## Silicon Errata for the CYT2BL Series Rev. A

Document Revision: 2.0

Date: 2023-10-17

This document describes the errata for CYT2BL Rev. A Series of devices. Details include trigger conditions, scope of impact, available workarounds, and applicable silicon revisions. Contact your local Infineon Sales representative for further questions.

Figure 2. CAN Frame with  $DLC > 4$

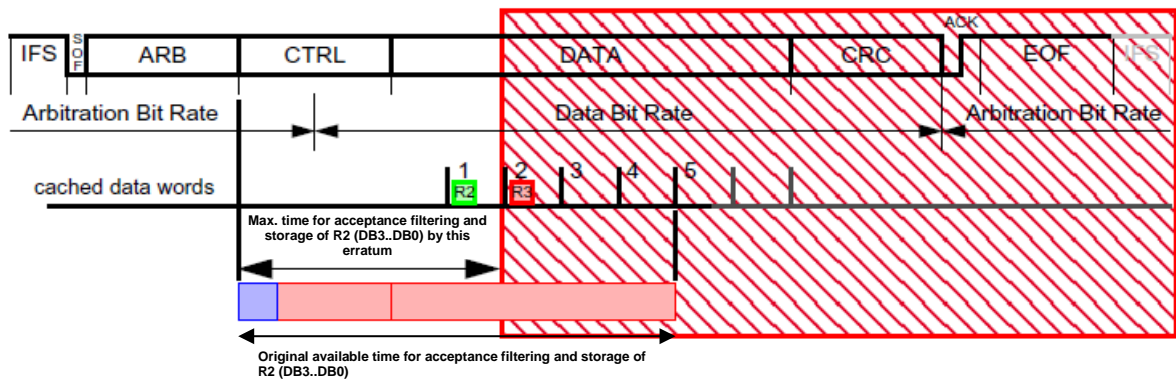
## 209. CAN FD sporadic data corruption (payload) in case acceptance filtering is not finished before reception of data R3 (DB7..DB4) is completed

Under the following conditions a received message will have corrupted data while the received message is signaled as valid to the host.

- 1) The data length code (DLC) of the received Message is greater than 4 ( $DLC > 4$ )
- 2) The storage of  $R_i$  of a received message into the Message RAM (after acceptance filtering is done) has not completed before  $R_{(i+1)}$  is transferred from the CAN Core into the cache of the Rx Handler (where  $2 \leq i \leq 5$ ).
- 3) While condition 1) and 2) apply, a concurrent read of data word  $R_i$  from the cache and write of data word  $R_{(i+1)}$  into the cache of the Rx handler happens.

The data will be corrupted in a way, that in the Message RAM  $R_{(i+1)}$  has the same content as  $R_i$ .

Figure 2 shows how the available time for acceptance filtering and storage is reduced.

First workaround

Try different configuration by changing the following parameters until the actual host clock frequency (CLK\_GR5) is above the minimum host frequency shown in Table 1.

- Increase the CLK\_GR5 frequency in the actual device
- Reduce the CAN-FD Data Bit rate
- Reduce the number of configured filter elements
- Reduce the number of active CAN channels in an instance

Also, use DLC>=8 instead of DLCs 5, 6, and 7 in the CAN Environment/System, as they place higher demands on the minimum Host clock frequency (the worst case is DLC=5) or restrict your CAN Environment/System to DLC 4.

Due to condition 3) the issue occurs only sporadically. Use an end-to-end (E2E) protection (for example, checksum or CRC covering the data field) and add it to all messages in the CAN system, to detect data corruption in received frames.
